SCALE: As-Noted  
 DATE: 1/17/00  
 PROJECT: Stockton CA, Parking Garage  
 Arch. Details, Parking Struct.

GENERAL CONTRACTOR  
 Turner Constr.  
 DRAWN BY: JM  
 CHECKED BY:  
 JOB NO. 1282  
 DRAWING NUMBER AD-9

CUSTOMER: TURNER CONST  
 PROJECT: ESSENTIAL SERVICES BLDG  
 LOCATION: STOCKTON, CA

ANCHOR BOLT LAYOUT GARAGE STAIRS

SECT. THRU LANDING

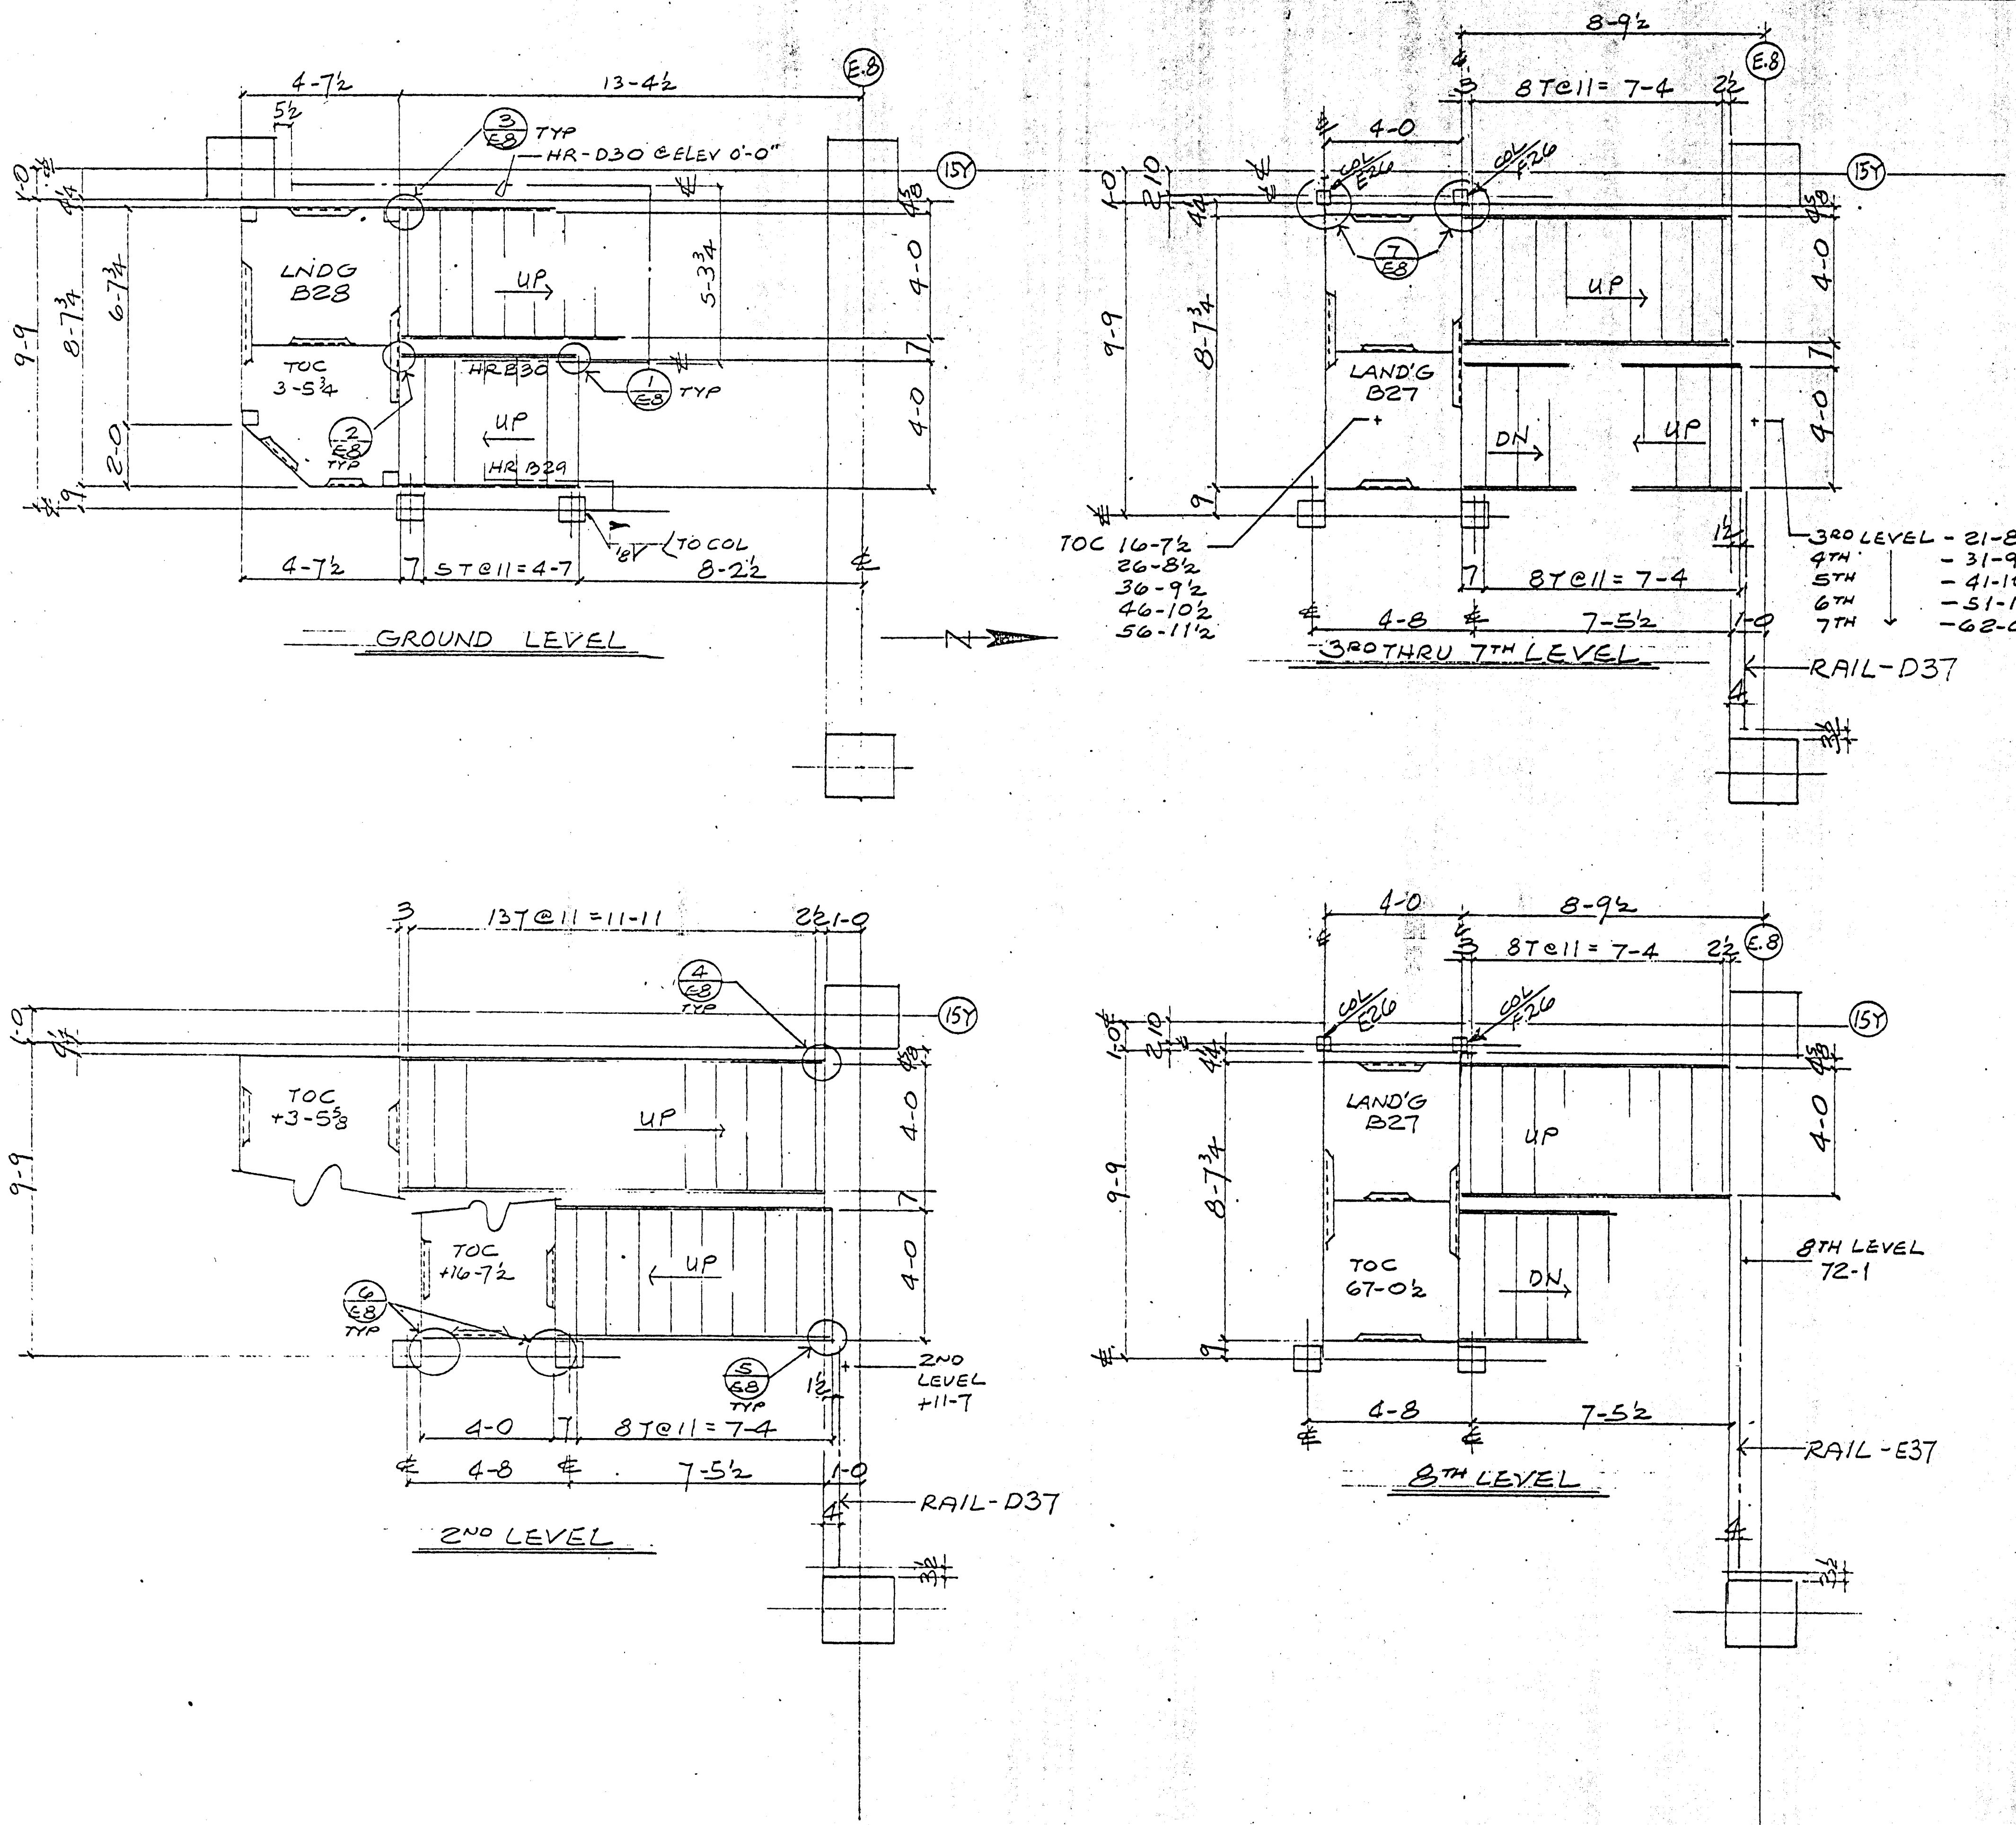
ALL BRACES PLANNED  
 Provide tie to column or  
 brace posts to ground for  
 lateral support  
 of landing

\* calc. + submit detail for approval @ lower landing

Provide contrasting color stripe at nosings per 7.24/ADA FINISH BY TOWER
